REGIONAL REVIEW FINDING

Name of Proposal: Herndon Homes (DRI 2677)

HERNDON HOMES DRI
City of Atlanta
Natural Resources Division Review Comments

Development of Regional Impact Assessment of Consistency with the Regional Transportation Plan

TITLE: DRI SITE PLAN

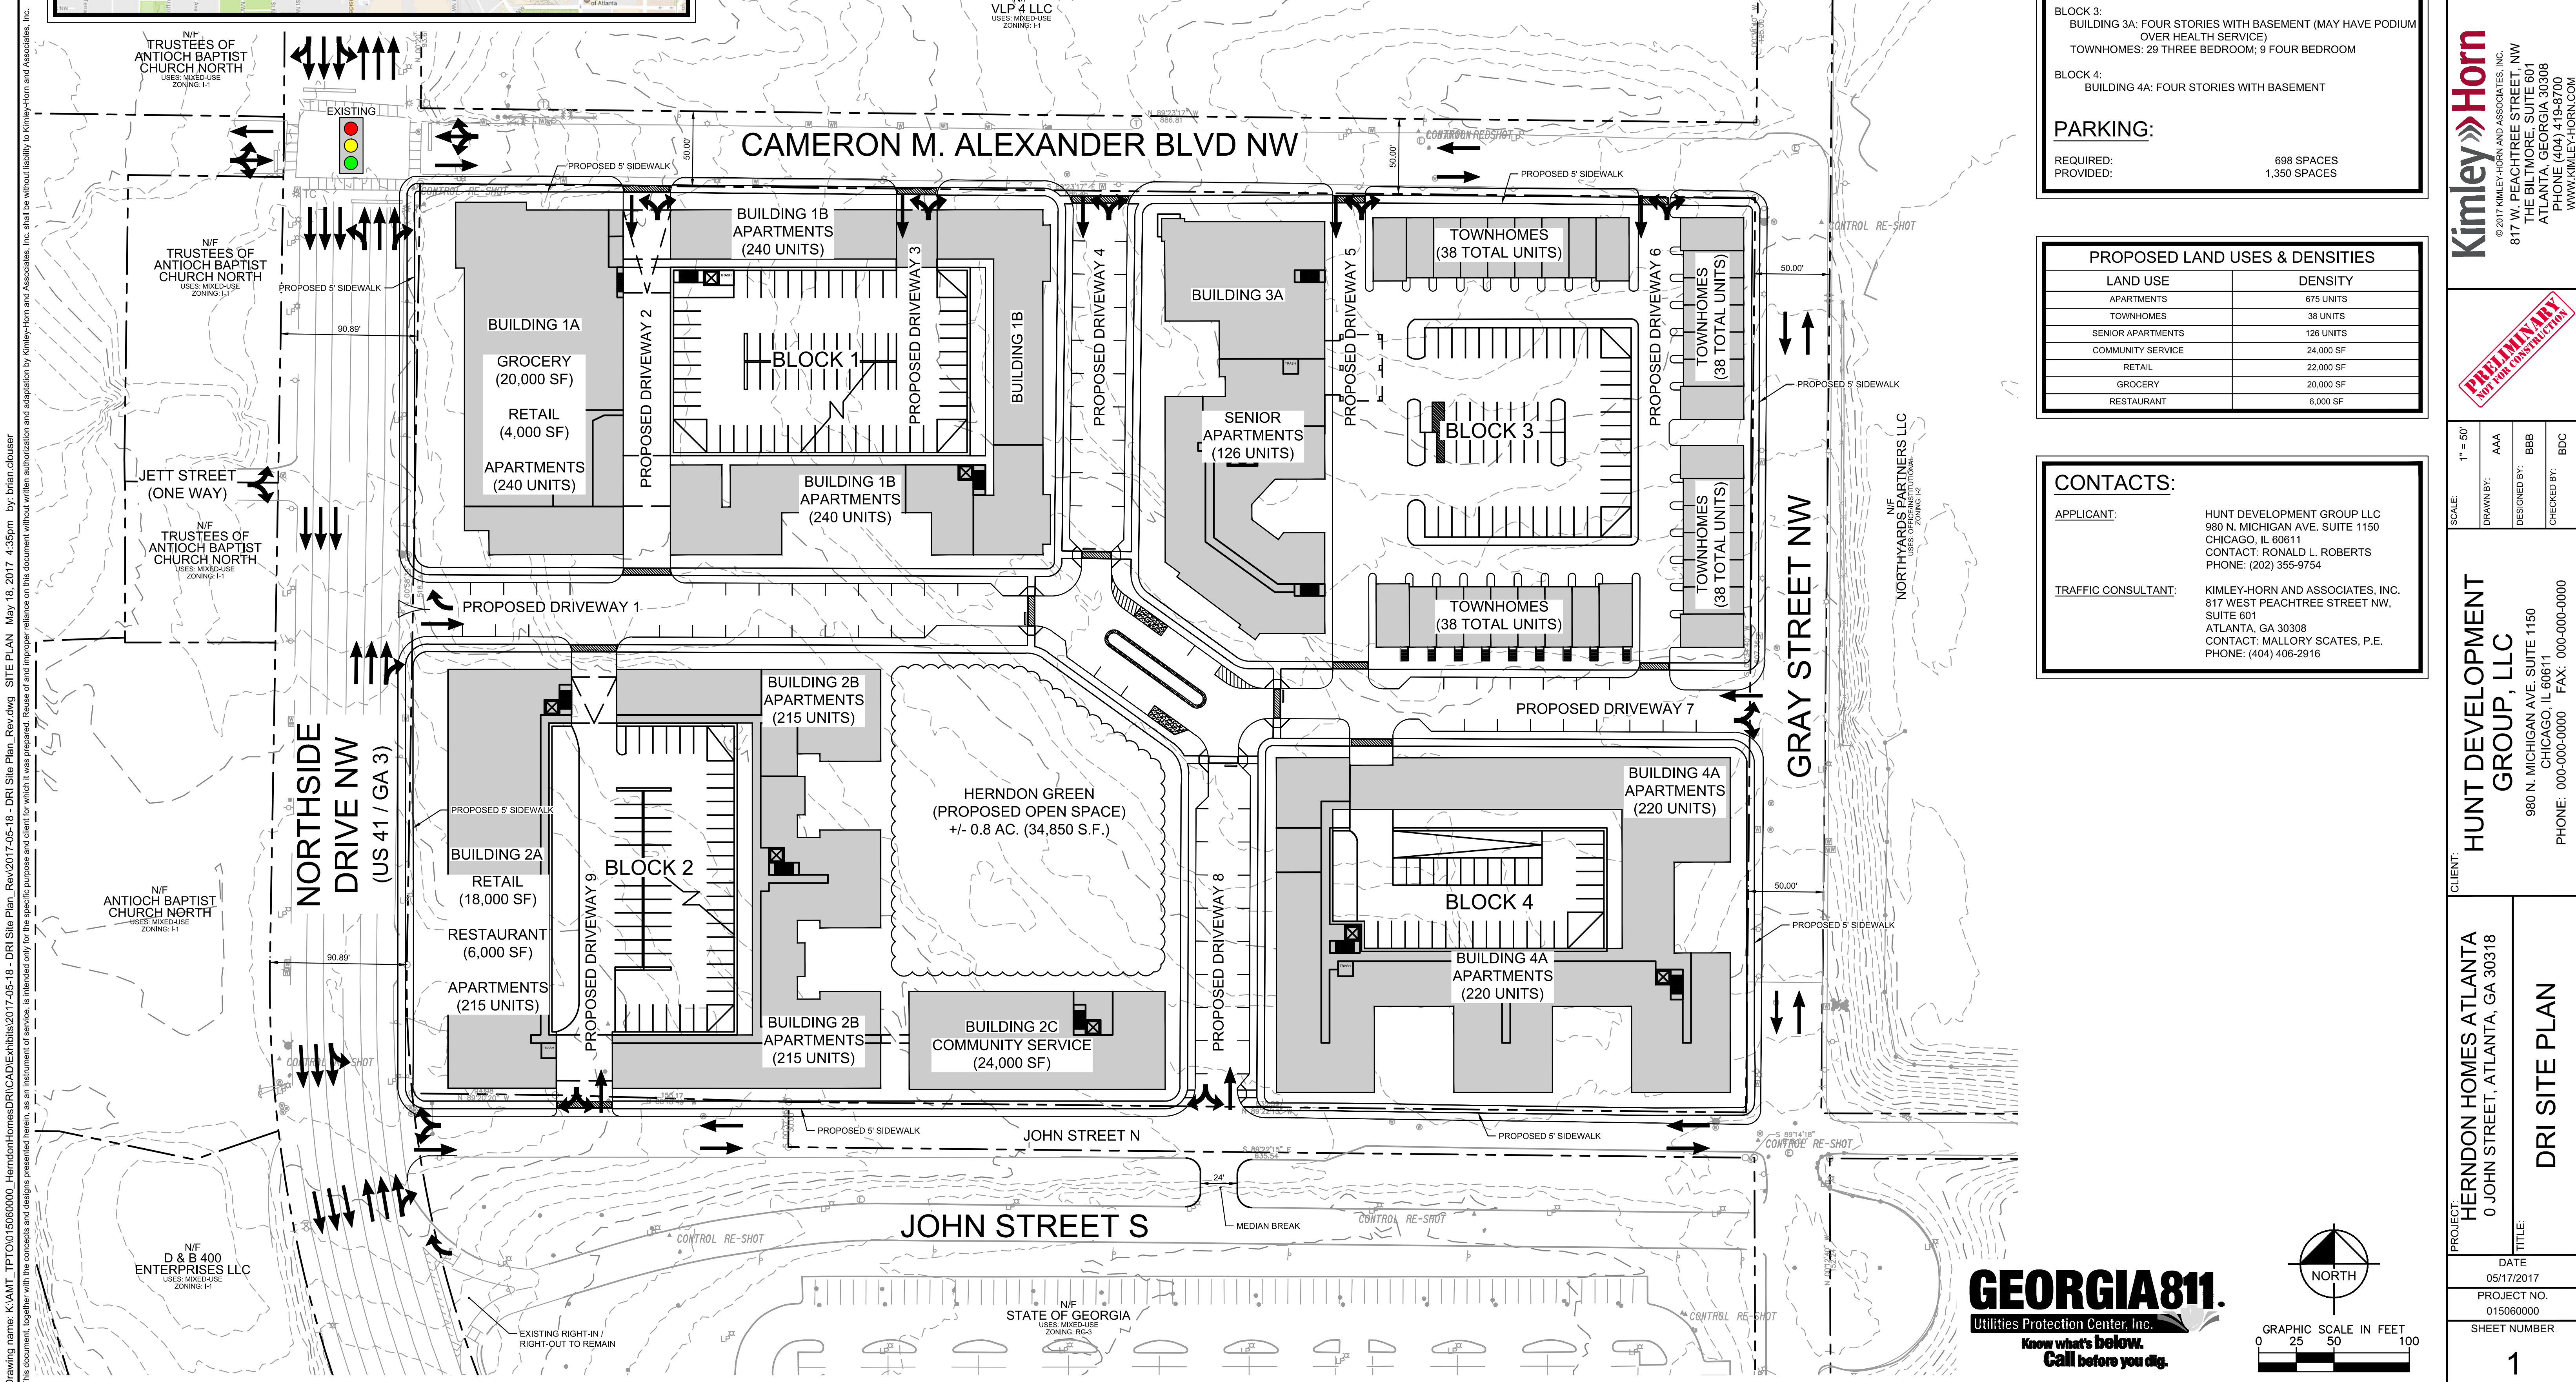
The development site is located a 12.5 acre parcel bounded by public streets on all four sides. Adjacent parcels on the east, west and south are currently developed. An undeveloped parcel is located to the north of the site; the two parcels are separated by Cameron M Alexander Blvd, a local roadway. The site plan depicts five access points on Cameron M Alexander Blvd.

The site plan and traffic analysis does not indicate bicycle and pedestrian facilities being provided throughout the 12.5-acre development site. Sidewalks currently exist on all adjacent roadways with partial sidewalks on John Street. The site plan indicates sidewalks and crosswalks being provided throughout the development allowing for pedestrian connectivity throughout the site.

In the interest of safety, the number of access points proposed on Cameron M Alexander Blvd should be reduced.

As a note regarding accessibility of services, senior housing is more than 600 feet from the nearest bus transit stop on the west side of Northside Drive at Cameron Madison Blvd, more than 400 feet from the retail (grocery store) with apartments (240 units) separating the uses. With seniors least likely to drive and the dependency of alternative modes use on the site, senior accessibility to uses should be considered.
